**Campaign for the Protection of Rural
Wales
Brecon and Radnor Branch
Upper Noyadd, Clyro, HR3 5JS
01497 820814**

HENDY WIND FARM: Land Off A44 SW Of Llandegley Llandrindod Wells Powys

Application for discharge of condition 9 from P/2014/0672 (APP/T6850/A/17/3176128):Micrositing Protocol

Figure 7.4 Peat Probing

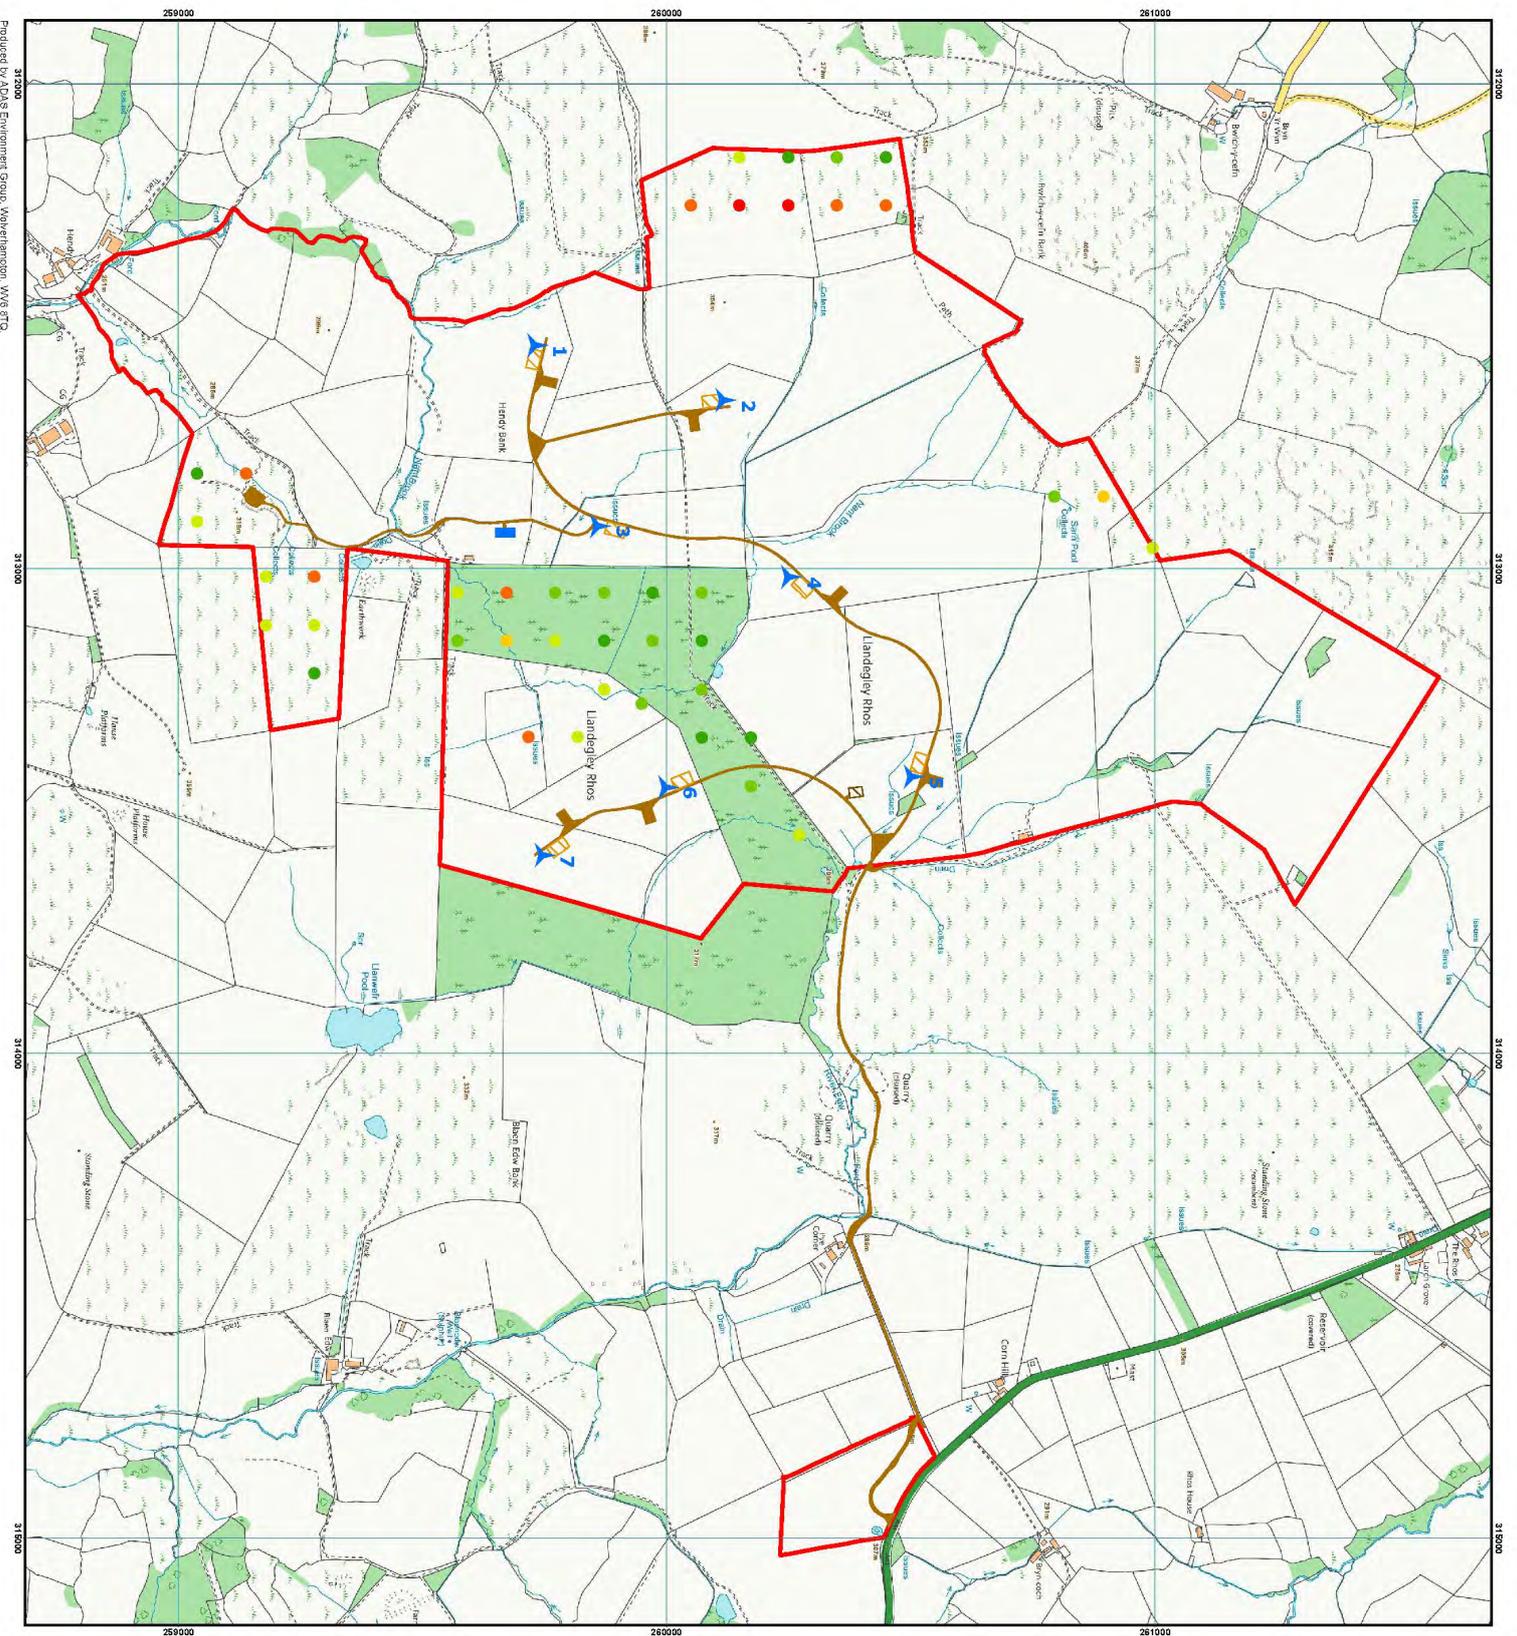
The ES says 44 peat depth recordings were made in winter 2012. These are confined to limited areas of the site (see ES Volume II fig 7.4.) and many are far from any intended development. There is no explanation of criteria for selection of the probing sites. West of T7, a peat of depth 100 – 124cm is recorded showing that deep peat is not confined to areas marked on the plan with marsh or woodland symbols.

There are no peat recordings in the vicinity of T5 (base already constructed with piles), the new section of track to T5 (already constructed), the northern track across the Common Land (already heavily used by HGVs and earmarked for AIL delivery of T5), the southern BOAT access route (the Developer has still not clarified which access options will

The report states that tracks to turbines 6 & 7 will only be micro-sited to areas of shallower peat. There are no peat depths recorded in the vicinity of T2, T3 and T6 which will be-sited. If peat depth is acknowledged to be a sensitive constraint for tracks, surely it is much more so for turbine bases of 2-2.5m depth (especially those like T5, already constructed, requiring bored piles- see ES 3.3.4).

Plan 1

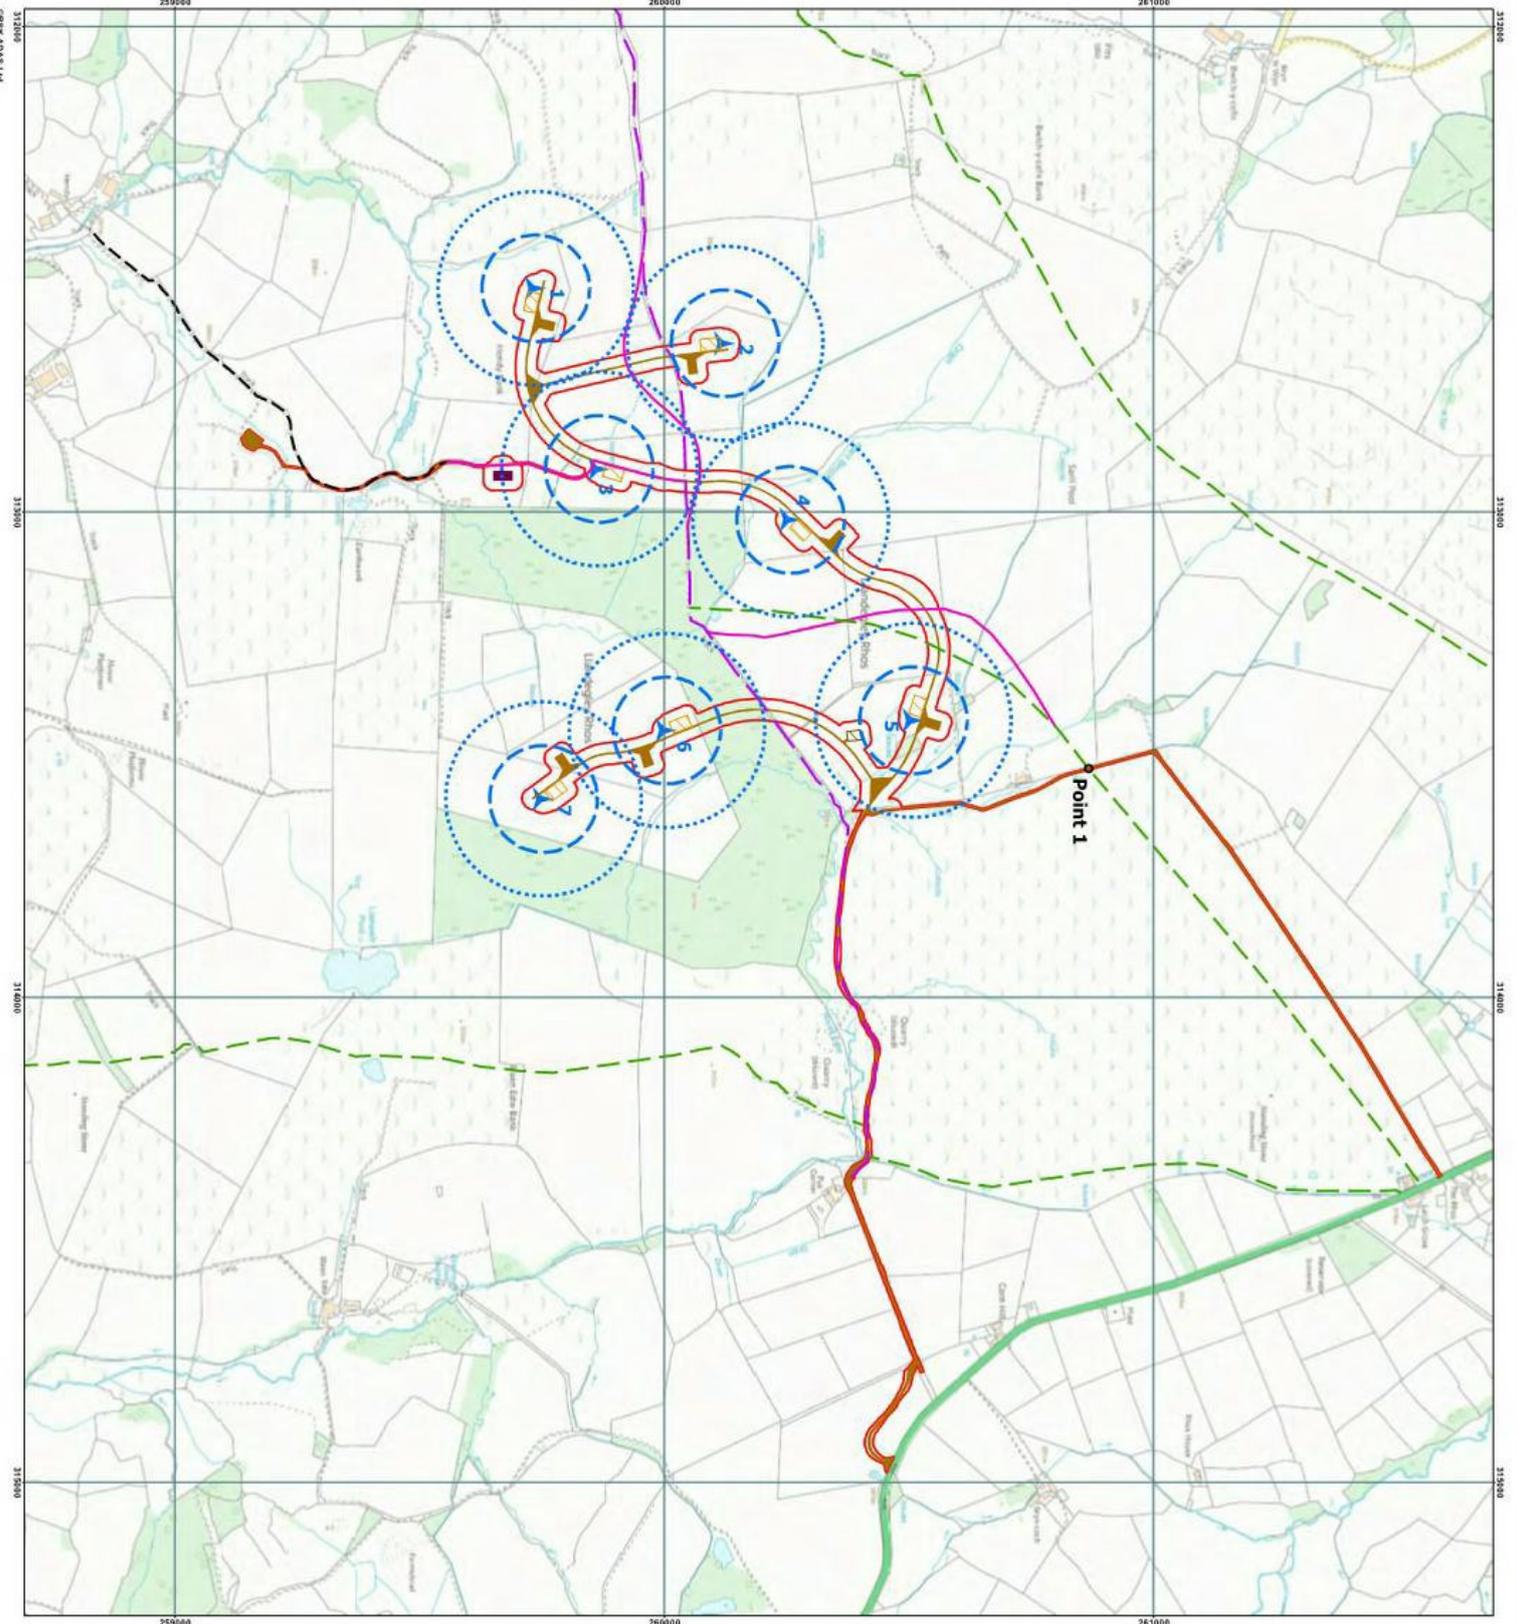
The Protocol does not say from which “PRoW” T2,T3 and T6 are to be distanced by micro-siting. The Protocol does not use the plural (PRoWs) and does not say how far the micro-siting will be. The hard standing and crane pads are shown in the approved WYG plans (see Condition 2) which replace the ES plans but which do not show the ProWs. The ProW plan (APP143) predates the substantial changes to plans introduced on the first day of the Public Inquiry. One of the principle flaws of this development is the manner in which the documentation fails to demonstrate how the wind farm construction and ProWs (existing and permissive) will be satisfactorily integrated so that they can be safely used by horses, bikes and walkers. We cannot understand why the 106 obligation plans were agreed.

For T6, the micro-siting is apparently to increase distance from the BOAT to 200m but T2 would have to be moved by 90m to achieve a 200m setback from the BOAT. This nonsensical situation is mirrored in the unsatisfactory trajectories of the “permissive rights of way”. The permissive snaking route from north of T5 to west, between T1 and T2, is clearly designed to mask the obvious public interest issue that the turbines are placed too close to the BOAT for health, safety and enjoyment of BOAT users. In stark contrast, the permissive route south from T3, far from providing a statutory setback from turbines, arises from the very centre of the T3 base which is not only highly dangerous, but physically impossible.
